**RE: Administrative Design Review Application Case No. PADR-004170-2024
601 Canyon Drive, Glendale CA 91206**

DESIGN REVIEW STAFF REPORT – SINGLE FAMILY

601 Canyon Drive

ADR-004170-2024

EXISTING SITE PLAN

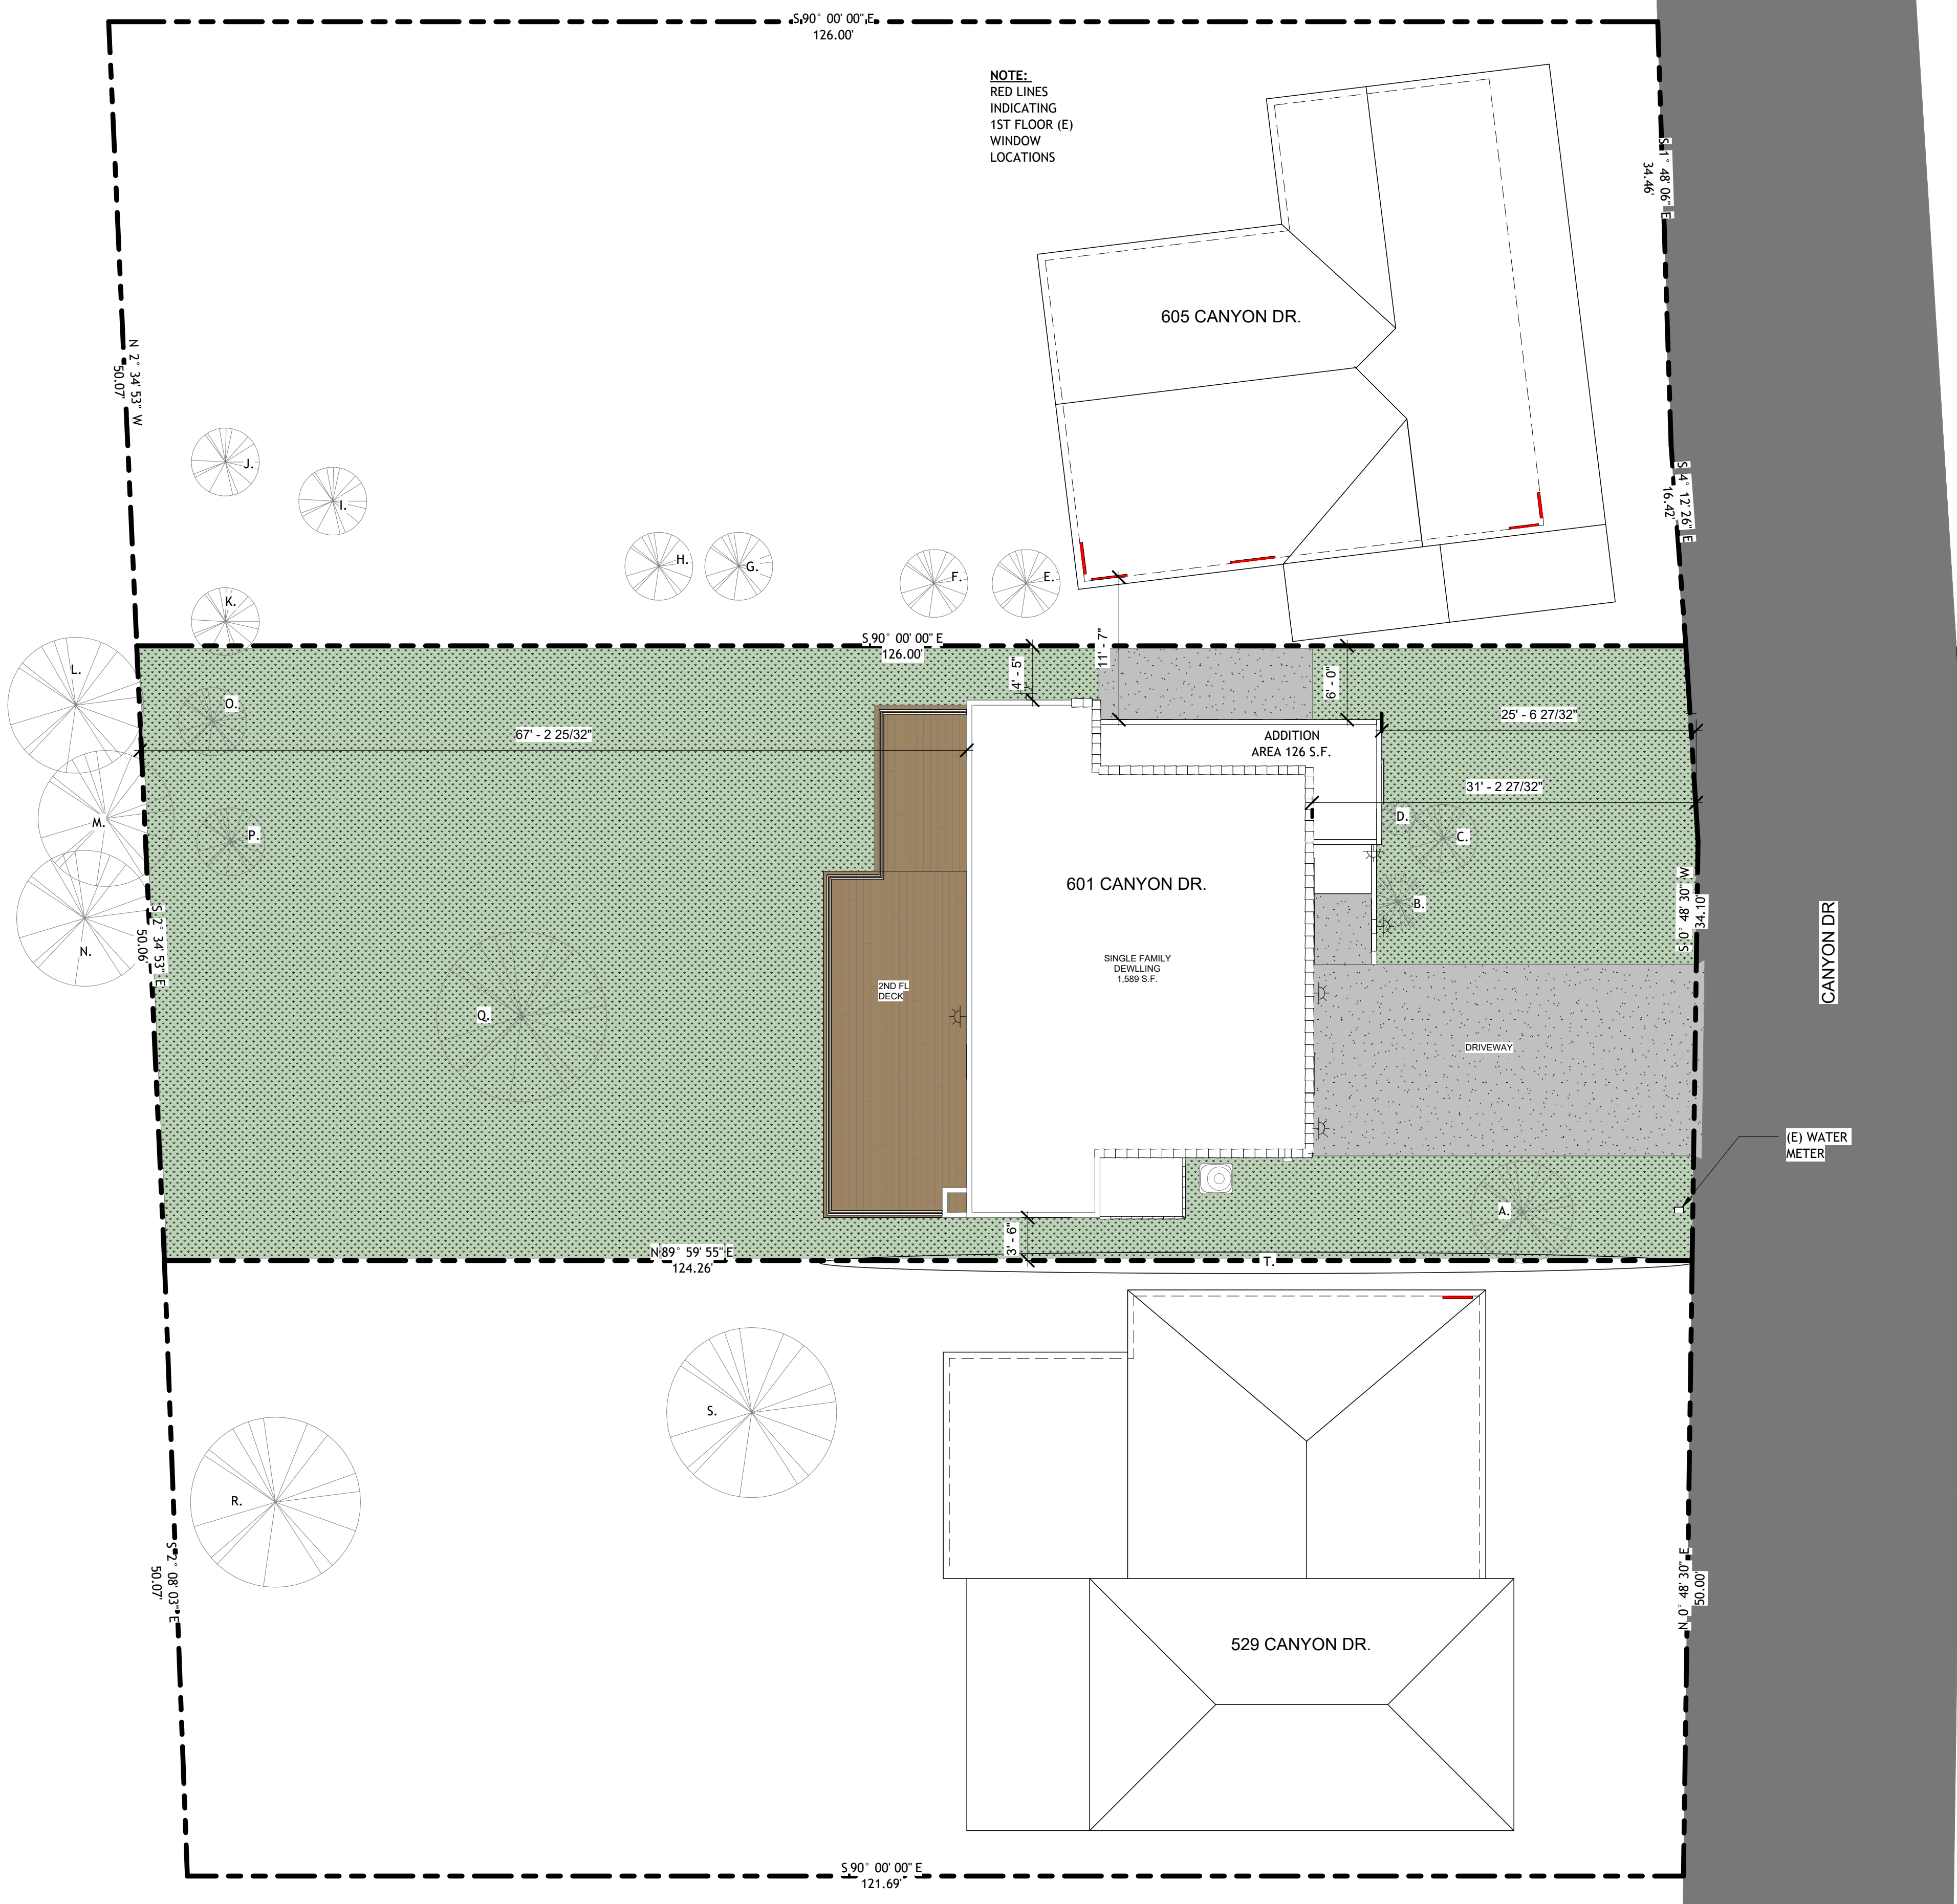
The project does not show a boundary fence that presently screens mechanical equipment in the interior setback. A condition is included that prior to the issuance of any building permit the site plan and elevations show a wall/fence to screen view of the mechanical equipment, as required by GMC §30.30.010, shall be submitted to staff for review and approval prior to plan check submittal.

1. The site plan and elevation shall be revised and submitted for staff review and approval before plan check completion. These documents shall detail all walls, fences, and the existing boundary fence screening mechanical equipment.
2. Add a forestry note representing there are no protected oak, sycamore, or bay trees on the property or within 20 feet of its boundaries.
